APPLICANT: Alabama Power Company
FACILITY: Joseph M. Farley Nuclear Plant, Unit 2
SUBJECT: SUMMARY OF OCTOBER 30, 1980 MEETING REGARDING REVIEW OF
OPERATING LICENSE APPLICATION

OCTOBER 30, 1980 MEETING
ALABAMA POWER COMPANY - NRC
OVERCURRENT PROTECTION

PROTECTION ANALYSIS FOR
RESPONSE TO NRC STAFF POSITION 040.15
CONTAINMENT PENETRATION OVERCURRENT PROTECTION
J. M. FARLEY NUCLEAR PLANT UNIT 2

FIGURE 2 - 600 V AC Load Centers

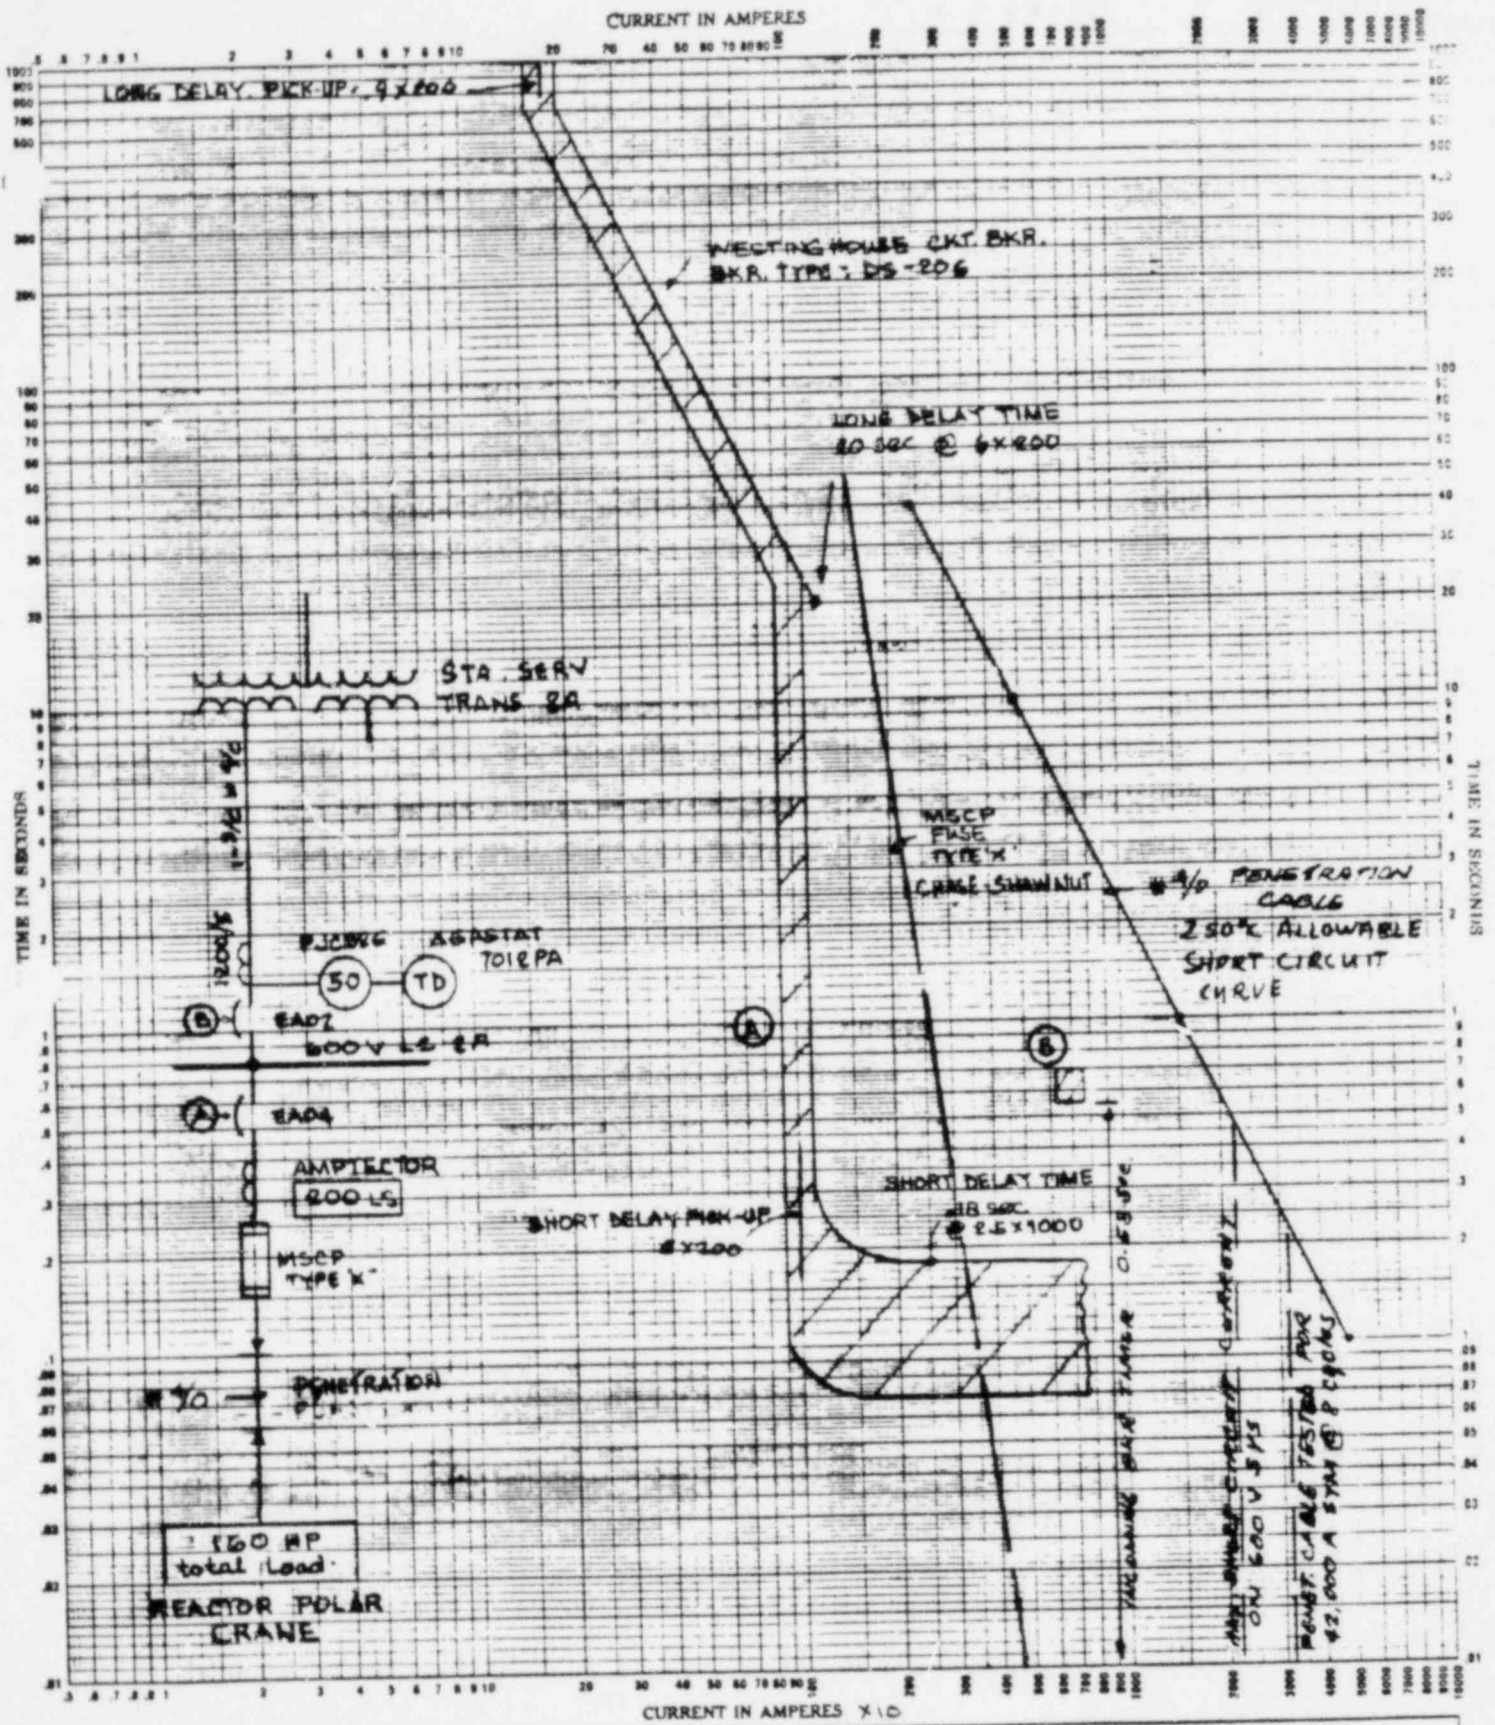
A. 600V AC Load Centers: Table 2 provides a tabulation of the loads inside the containment which are powered from 600V AC load centers. As shown on Figure 2, the existing load feeder breakers which provide the primary overcurrent protection provide both short circuit and overload protection for the containment penetration conductors. However, the existing bus supply breakers are magnetic trip only breakers and as shown on Figure 2 do not provide thermal overload protection. Therefore, a modification will be made to provide MSCP fuses in series with each phase of the power cables for the loads in Table 2.* The MSCP fuses will be located between the load center feeder breakers and the containment penetration conductors as shown on the single line on Figure 2. The MSCP fuses will provide adequate backup overload and short circuit protection for the containment penetration conductors as shown on Figure 2.

FIGURE 3 - 600 VAC MCC

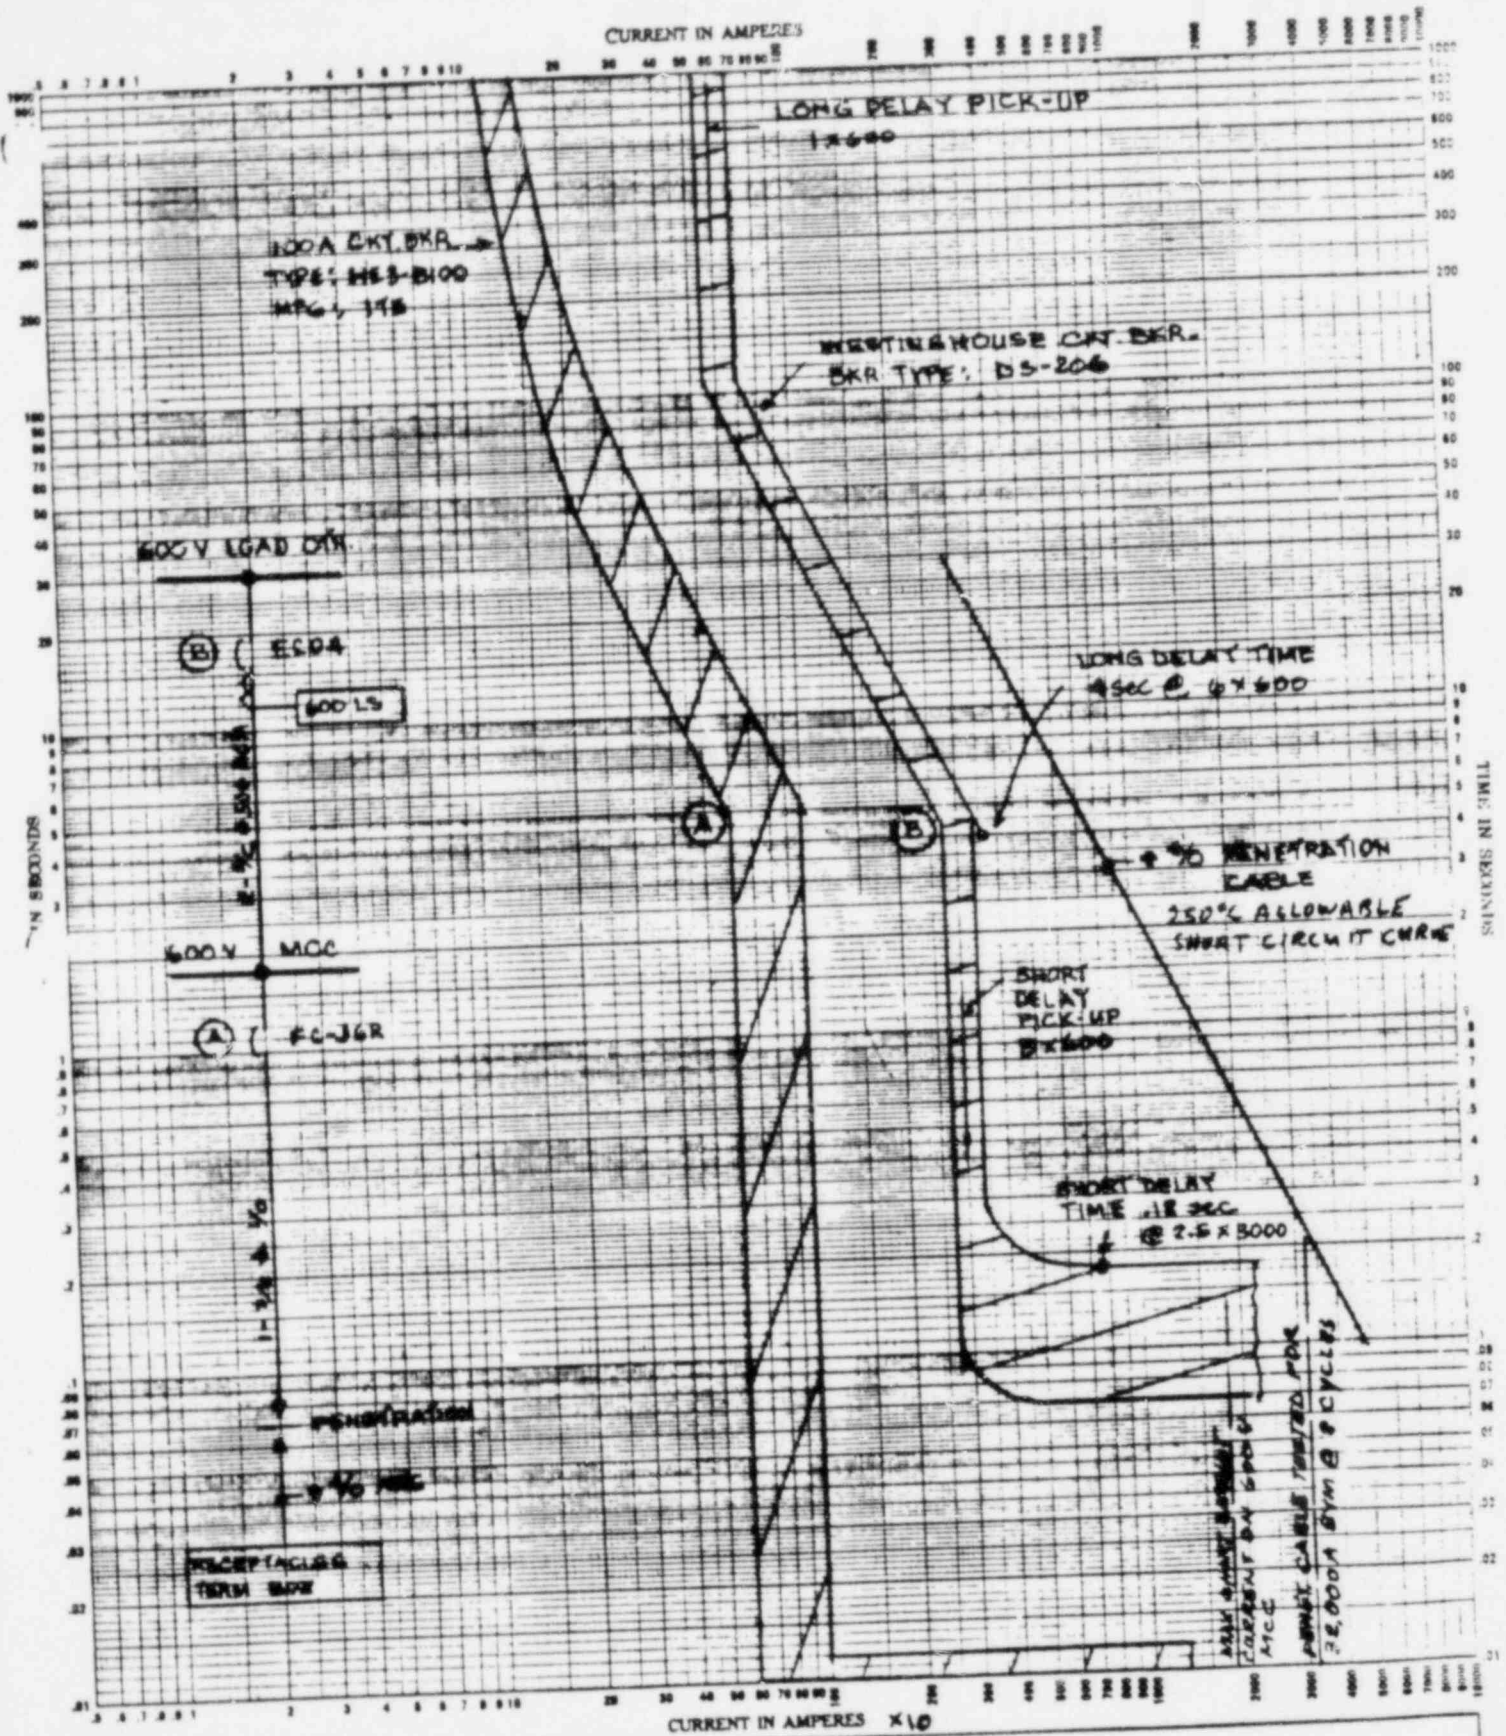
Figure 3 shows the time-current coordination curves for the existing overcurrent protection devices associated with the #4/0 AWG penetration conductors. As shown in Figure 3, adequate time-current coordination exists between the 600V MCC breaker feeding the load and the 600V load center breaker which supplies the MCC to provide primary and backup overload and short circuit protection for the #4/0 containment penetration conductors.

FIGURE 4 - 600 VAC MCC

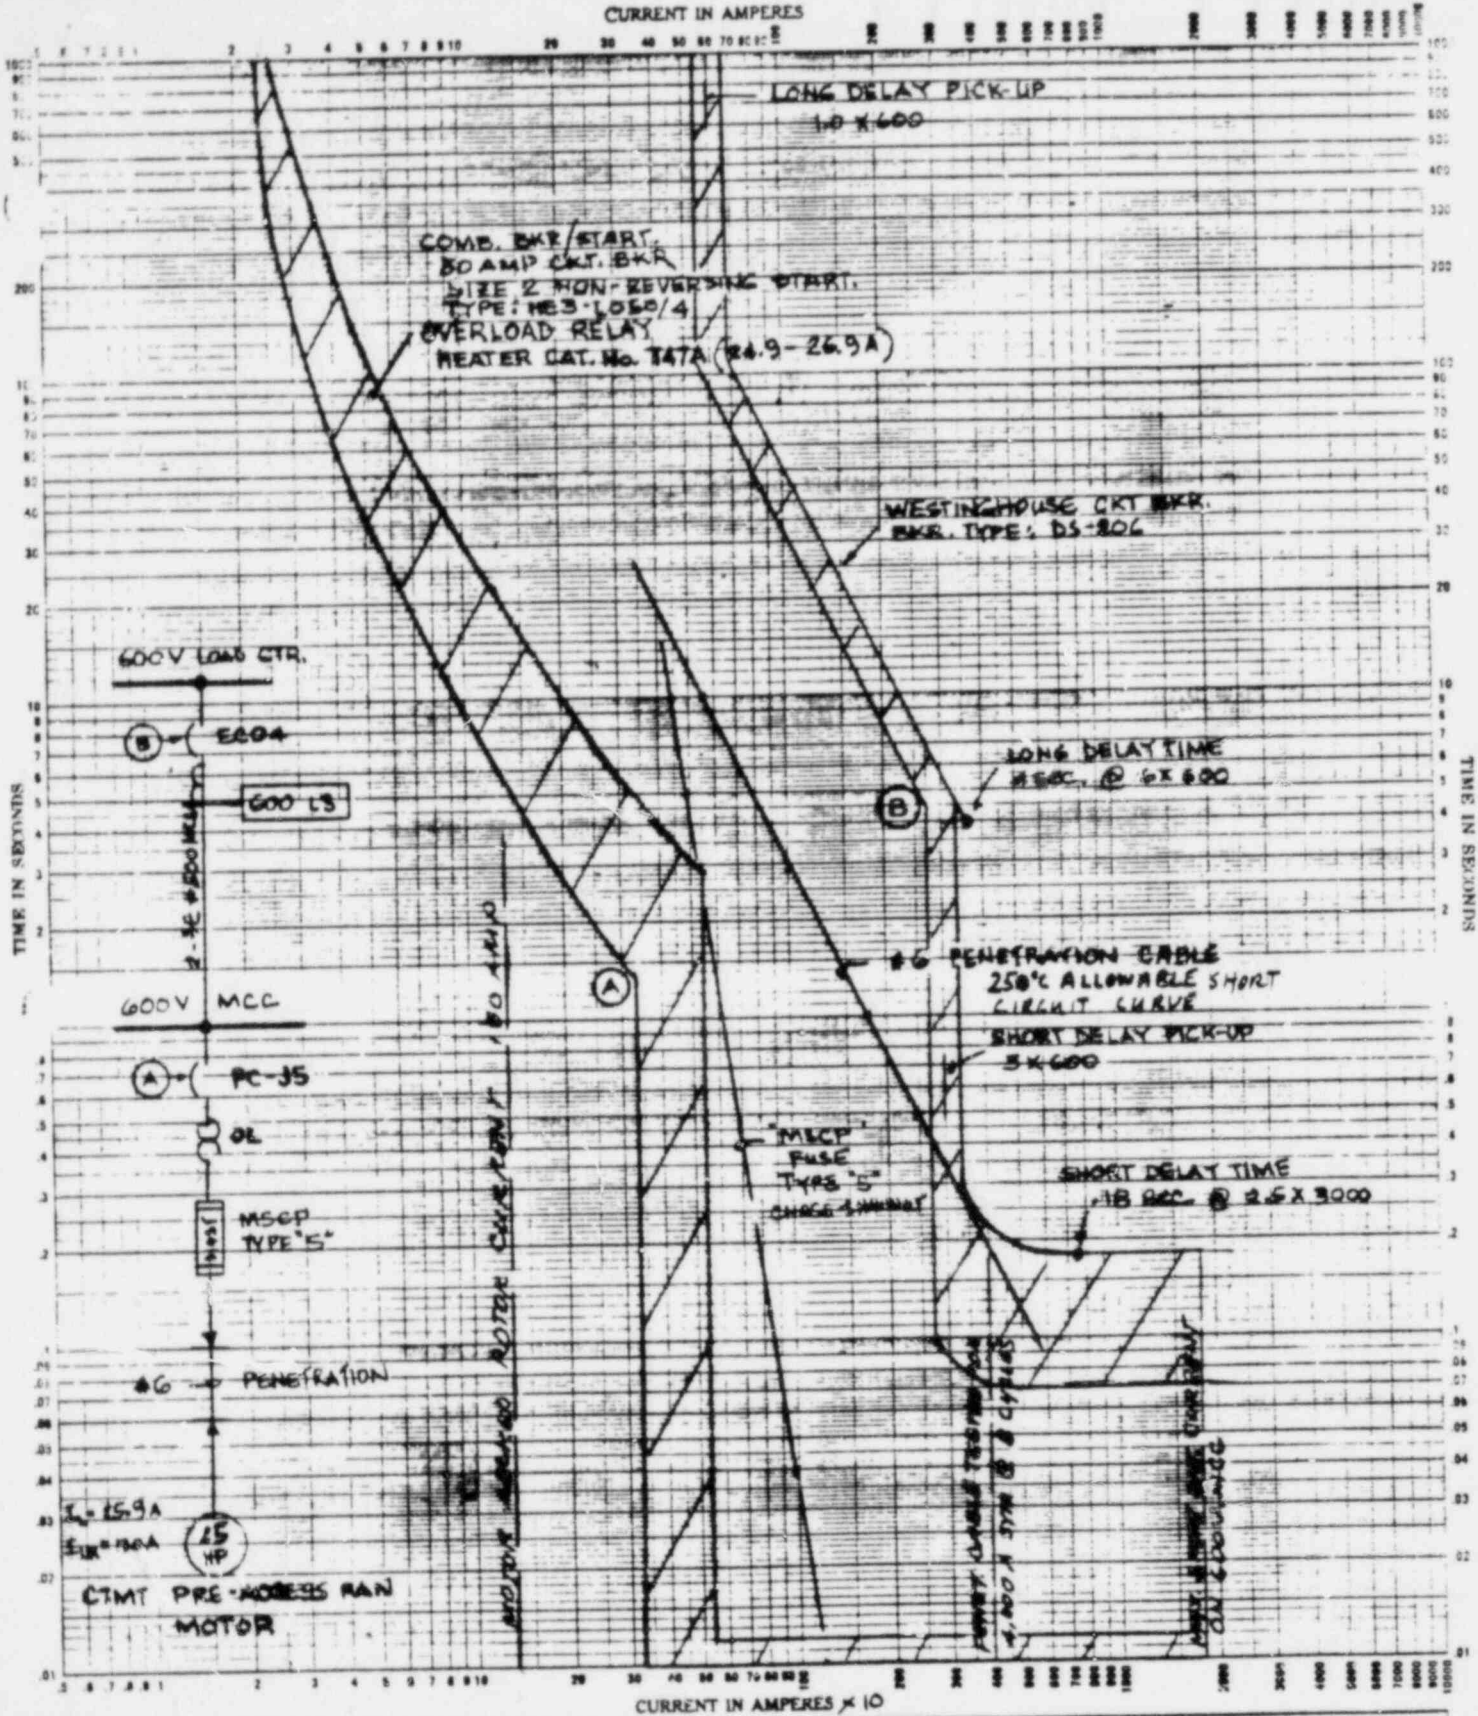
Figure 4 shows the time-current coordination curves for the existing overcurrent protection devices associated with the #6 AWG containment penetration conductors. As shown on Figure 4, the existing 600V MCC breakers and O/L relays provide primary overcurrent protection for both short circuit and overload protection of the containment penetration conductors. However, the existing 600V load center

breakers which supply the 600V MCC's do not provide adequate backup overcurrent protection. Therefore, a modification will be made to provide MSCP fuses in series with each phase of the power cables for the loads in Table 3* which use #6 AWG penetration conductors. The MSCP fuses will be located between the 600V MCC's and the containment penetration conductors as shown on the single line on Figure 4. The MSCP fuses will provide adequate backup overload and short circuit protection for the #6 AWG penetration conductors as shown on Figure 4.

FIGURE 5 - 600 VAC MCC

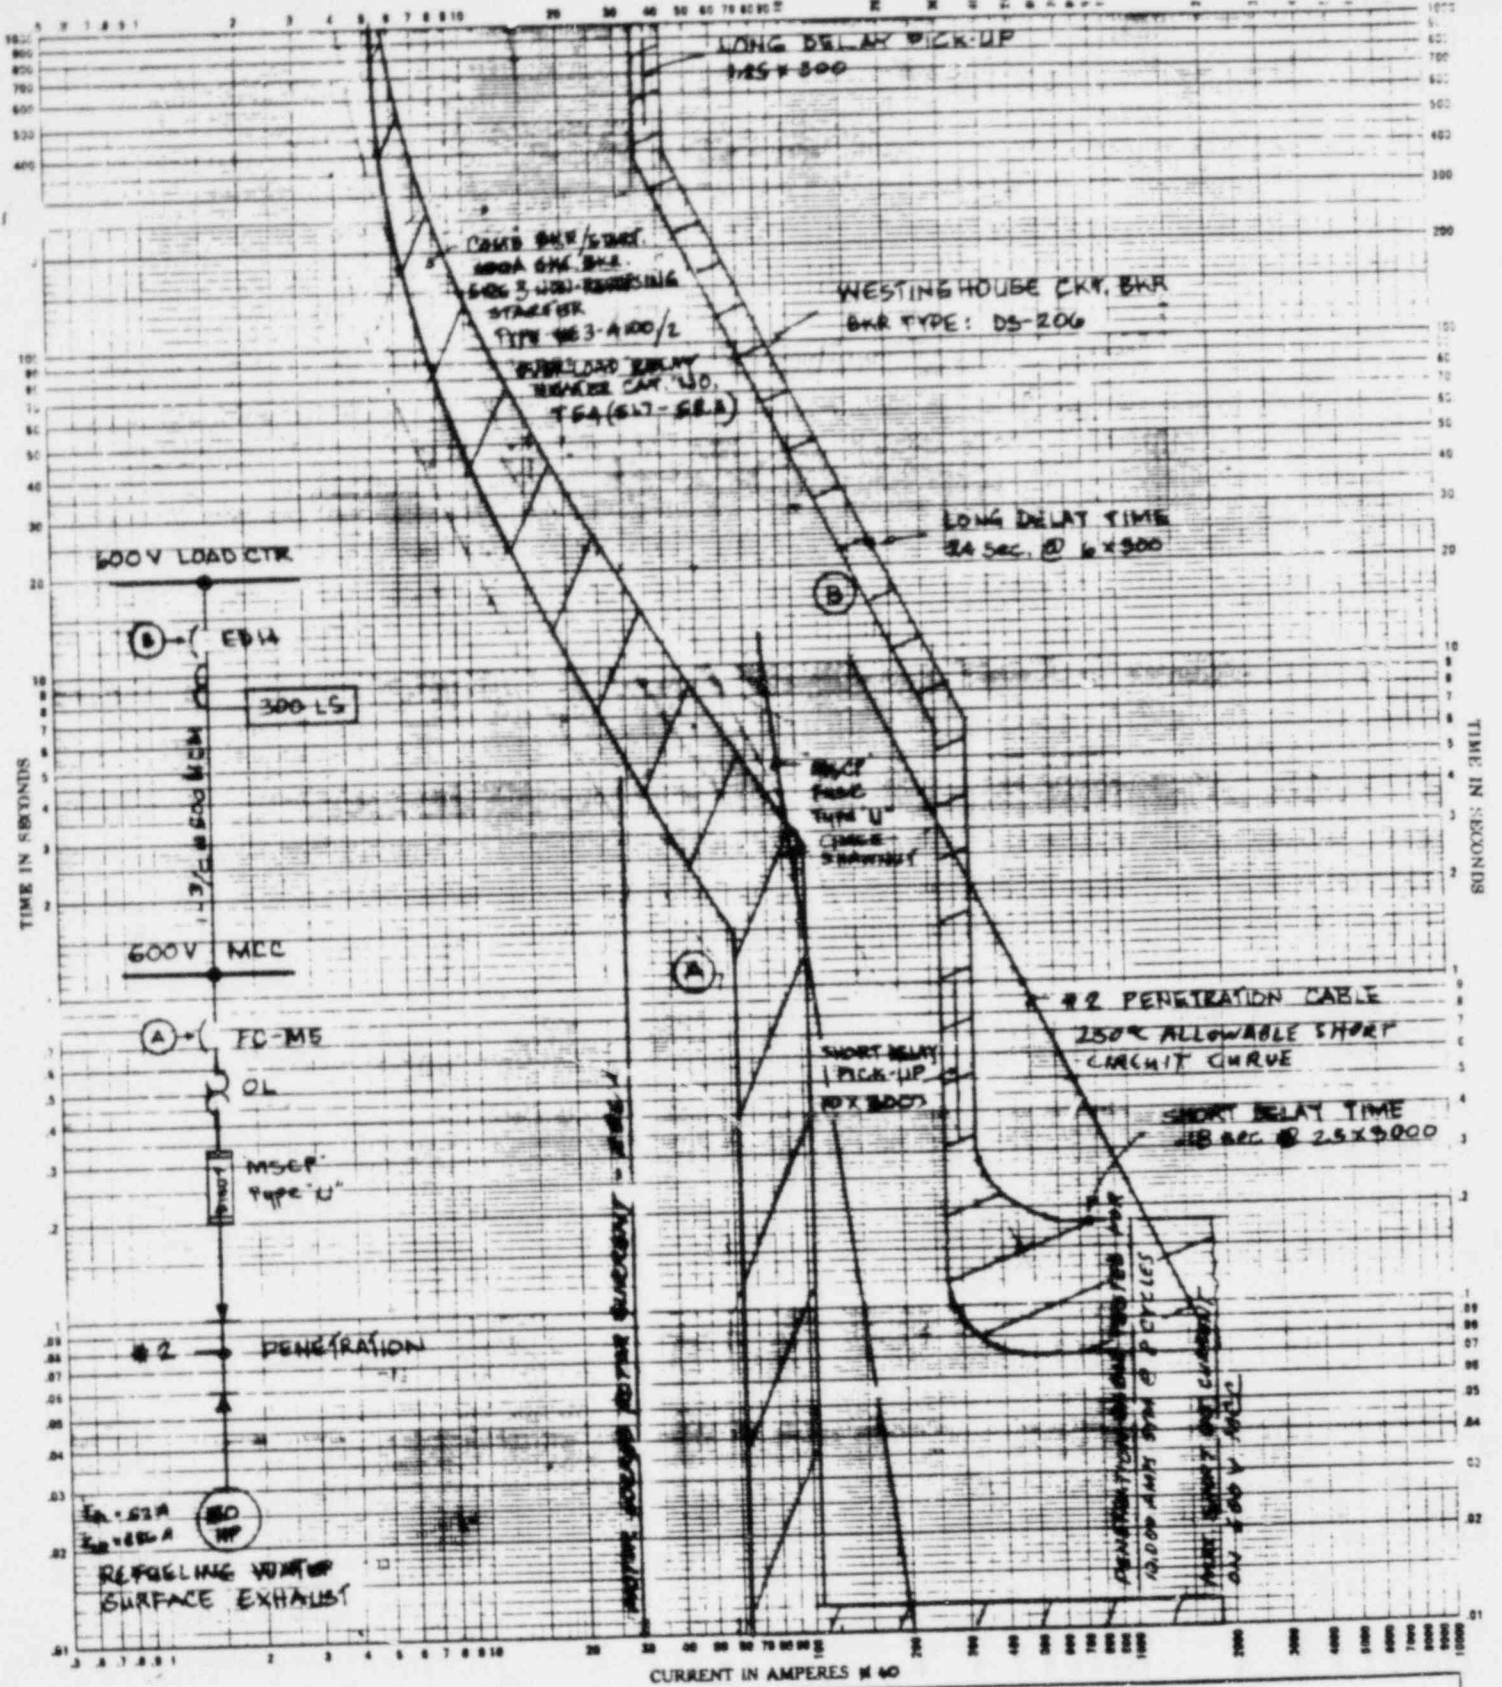
Figure 5 shows the time-current coordination curves for the existing overcurrent protection devices associated with the #2 AWG containment penetration conductors. As shown on Figure 5, the existing 600V MCC breakers and O/L relays provide adequate primary overcurrent protection for both short circuit and overload protection of the penetration conductors. However, the existing 600V load center breakers which supply the 600V MCC's do not provide adequate backup overcurrent protection. Therefore, a modification will be made to provide MSCP fuses in series with each phase of the power cables for the loads in Table 3 which use #2 AWG penetration conductors. The MSCP fuses will be located between the 600V MCC's and the containment penetration conductors as shown on the single line on Figure 5. The MSCP fuses will provide adequate backup overload and short circuit protection for the #2 AWG containment penetration conductors as shown on Figure 5.
